UNITED STATES
NUCLEAR REGULATORY COMMISSION
WASHINGTON, D. C. 20555

APPLICANT: Public Service Electric & Gas Company (PSE&G)
FACILITY: Hope Creek Generating Station
SUBJECT: SUMMARY OF STRUCTURAL AND GEOTECHNICAL ENGINEERING
BRANCH (SGEB) MEETING

On August 1, 1984, a meeting was held in the Bethesda, Maryland offices of the NRC to discuss the remaining SGEB-Structural audit open items identified in the Draft SER. A list of meeting attendees is included as Enclosure 1 to this meeting summary.

FIGURE A-16-13
RESPONSE SPECTRA COMPARISON,
INTAKE STRUCTURE AT ELEV. 93' - 0".

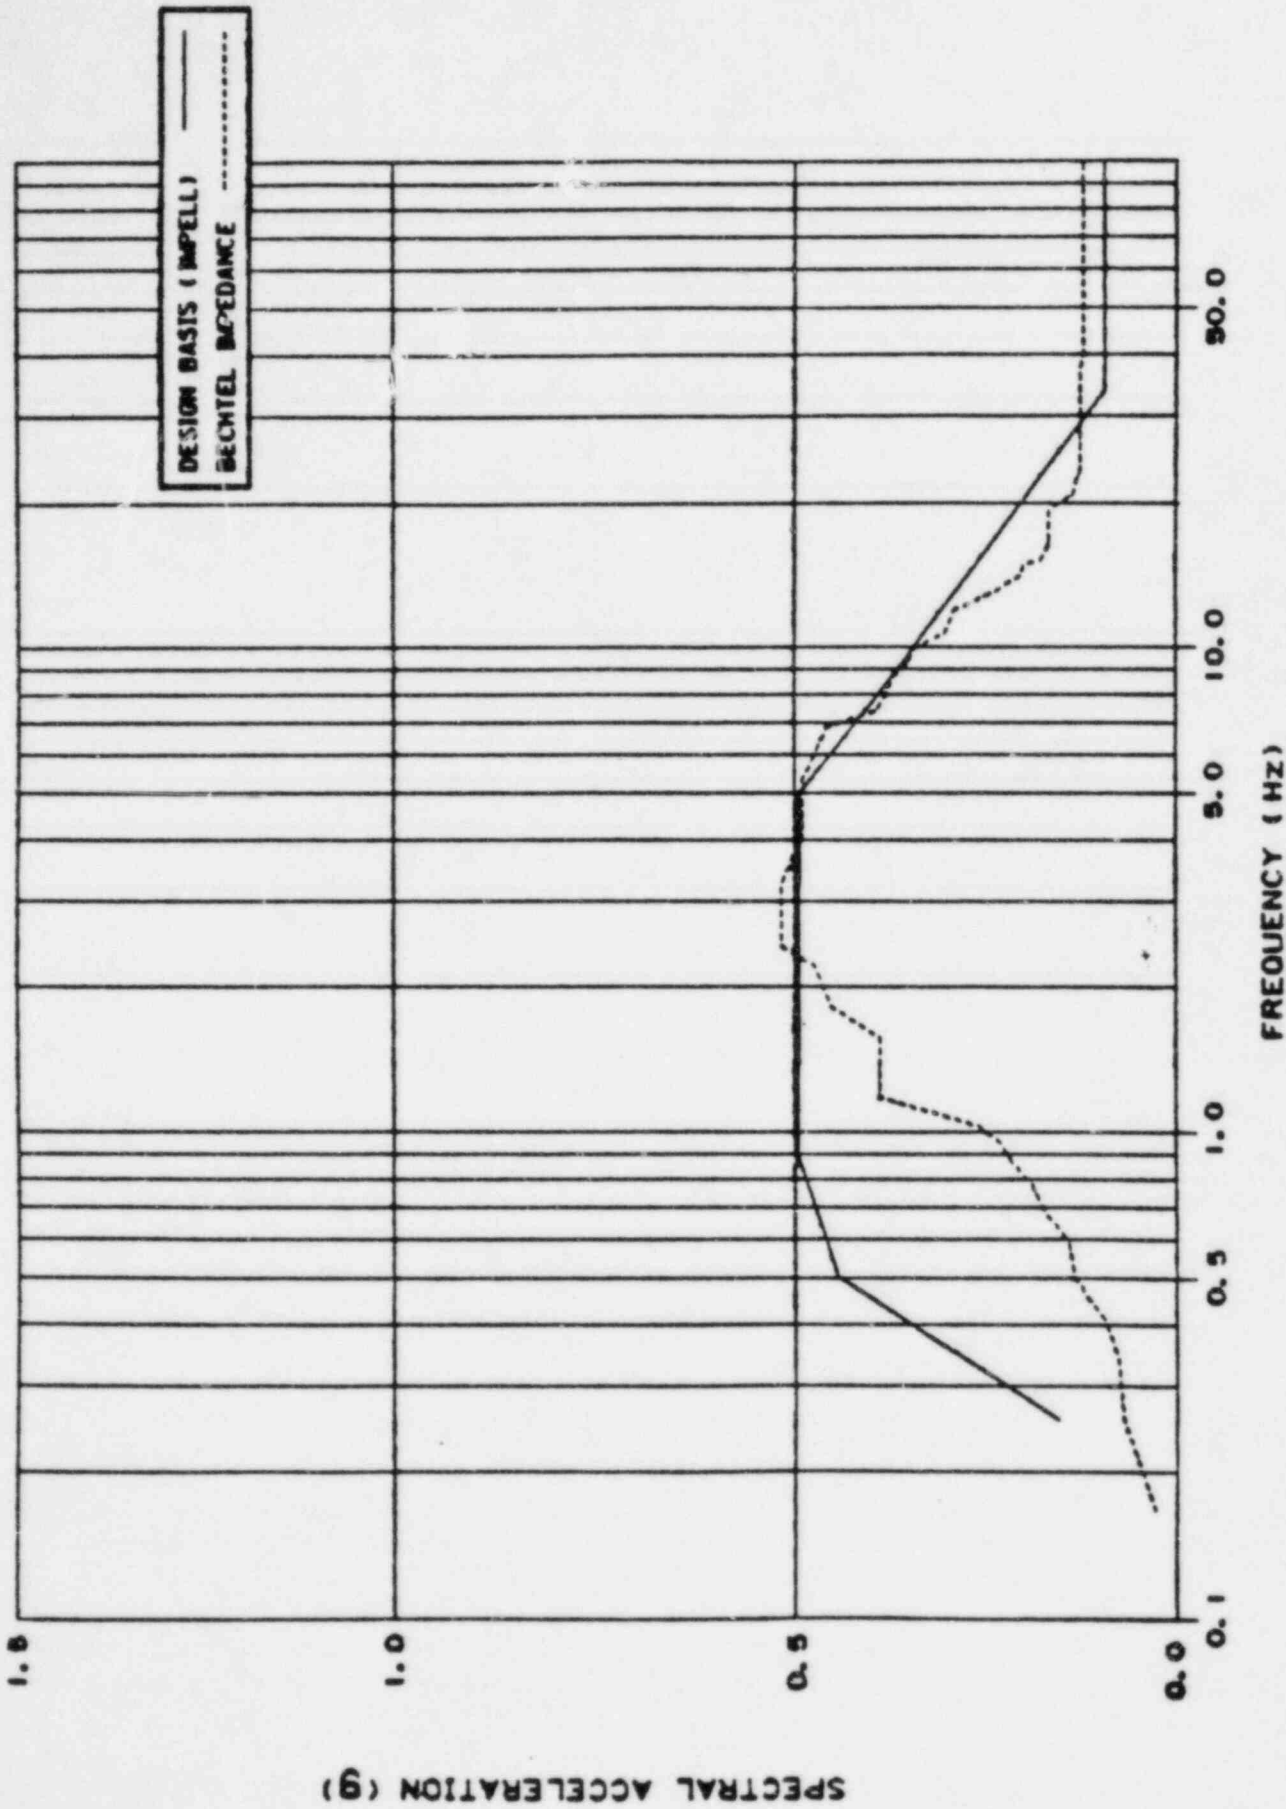
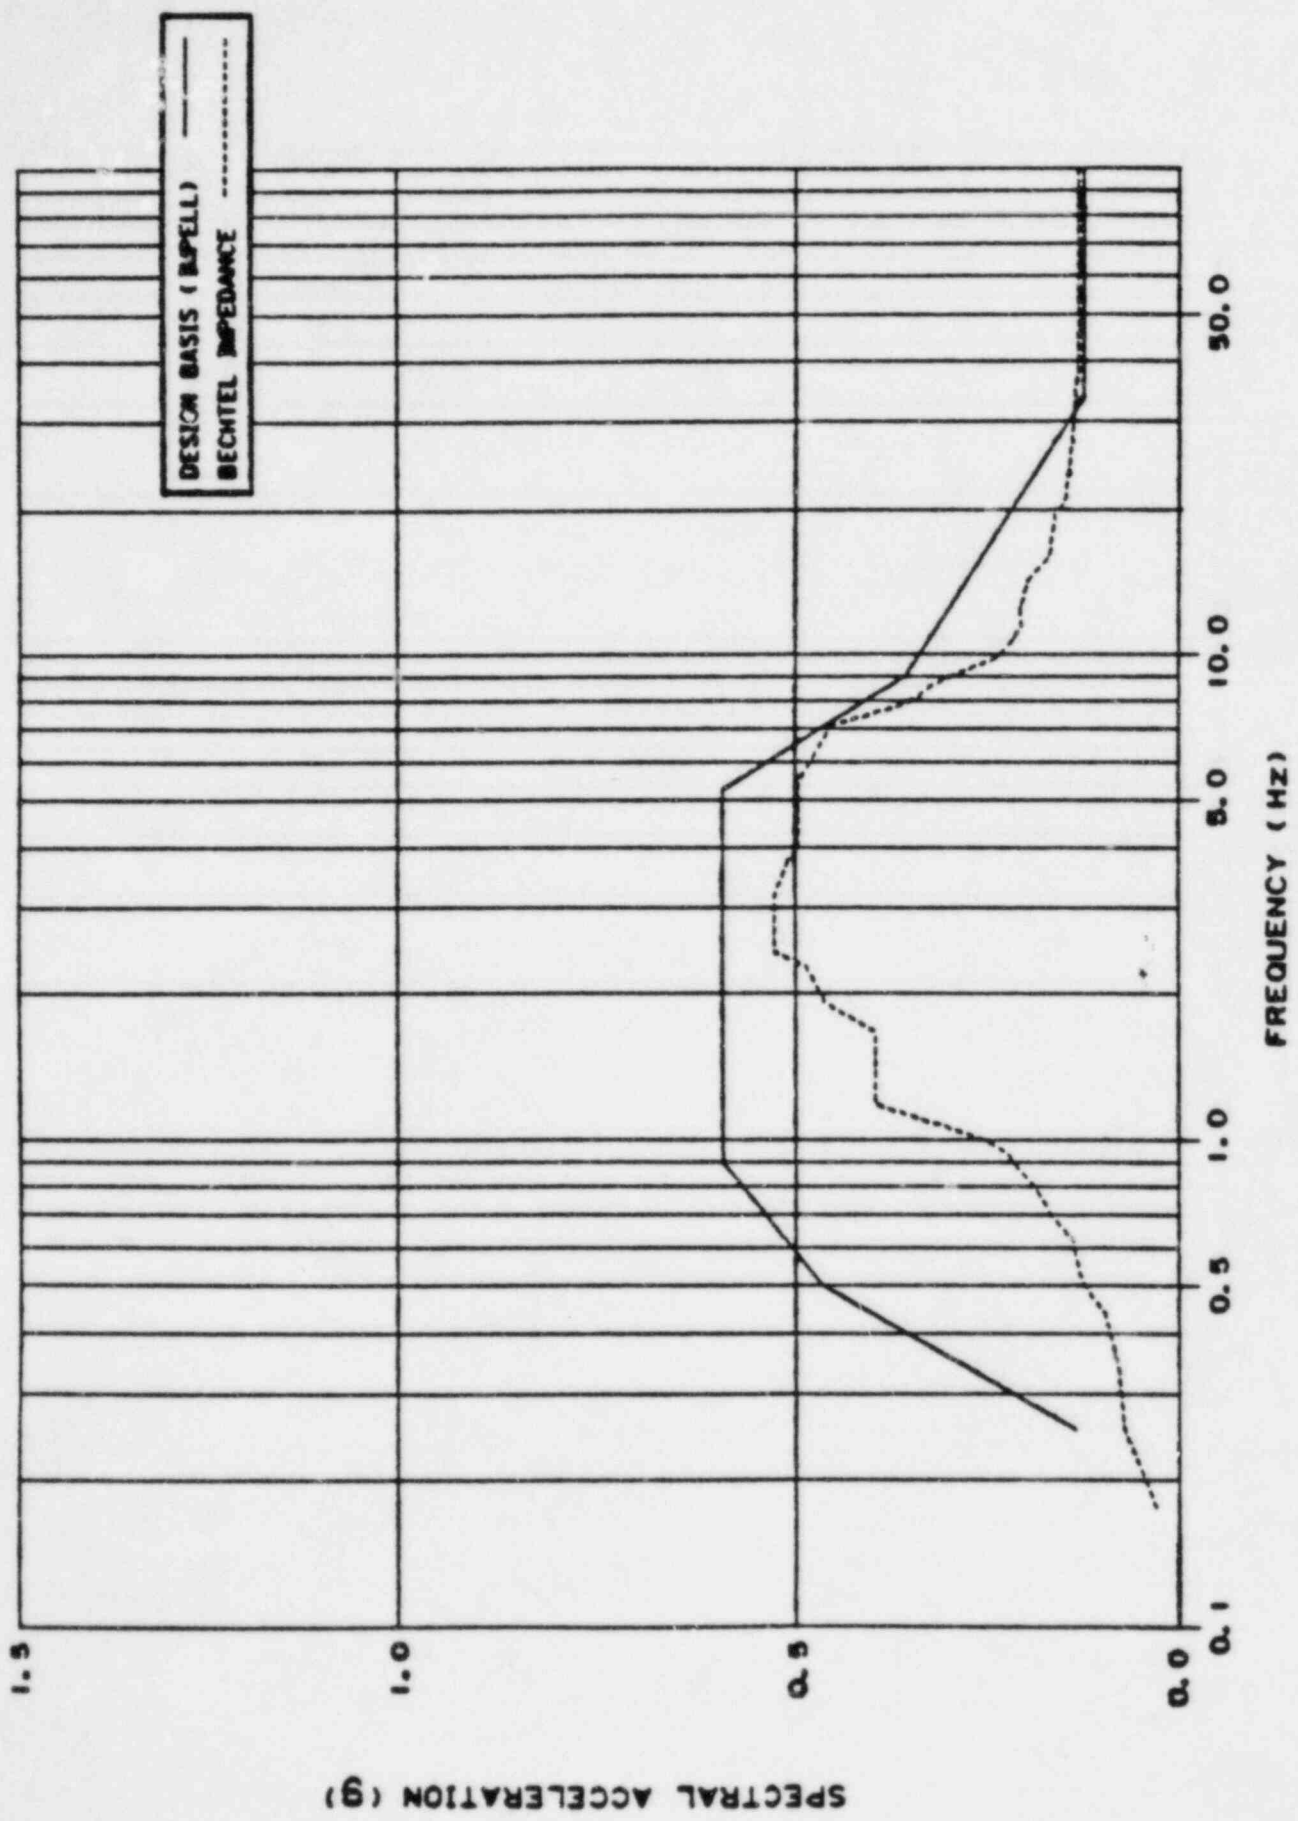
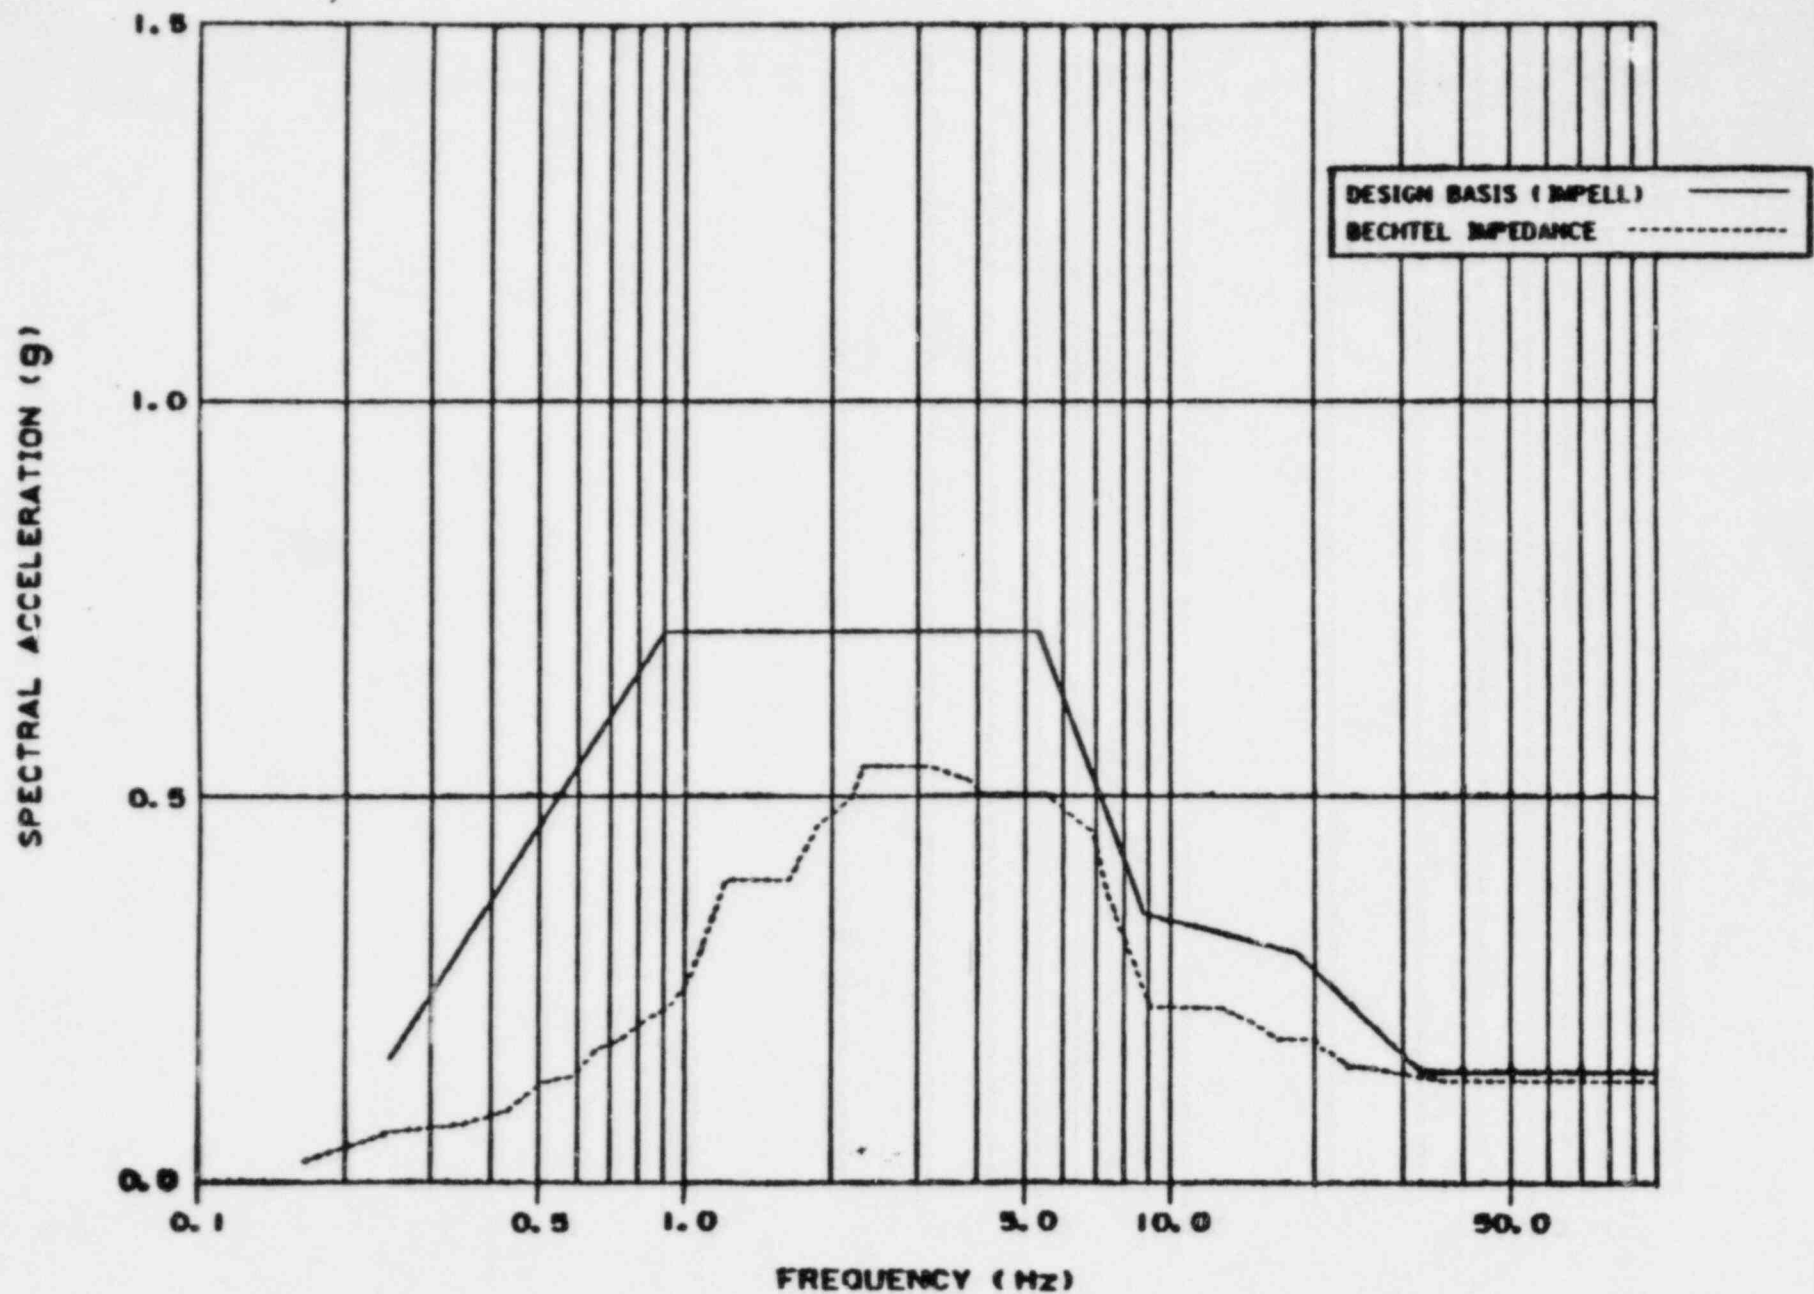
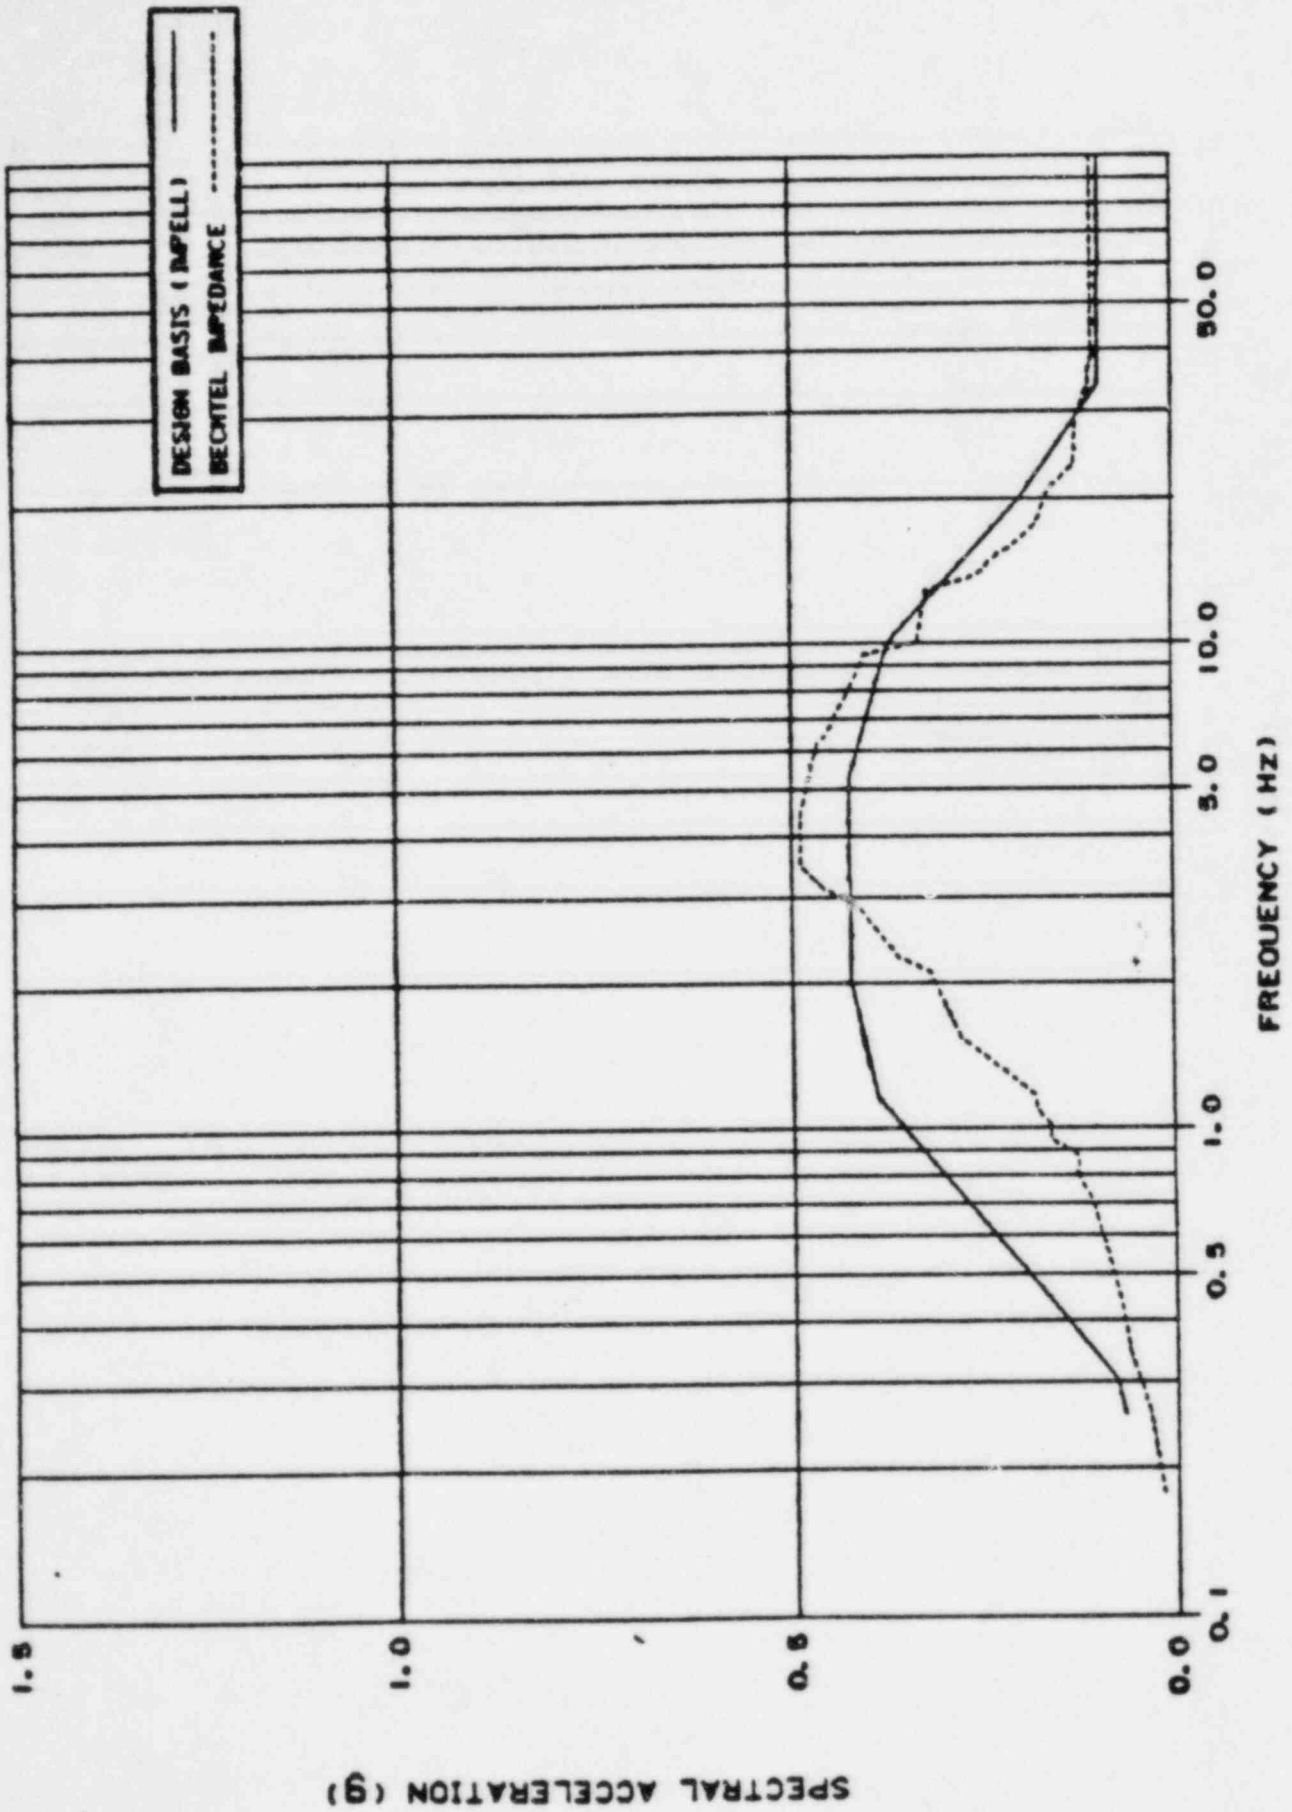
Question No.: A-16

Figures A-16-1 to A-16-18 show the comparison of the 2 percent damping response spectra obtained from the design basis finite element and the impedance approach seismic soil-structure interaction analyses. The impedance approach response spectra generally are enveloped by those obtained from the design basis analyses at elevation 114.0 feet of the SWIS. For other elevations, the impedance approach spectral accelerations exceed the design basis spectral accelerations in some frequency ranges. These ranges vary approximately between 1.5 and 10.0 Hz.
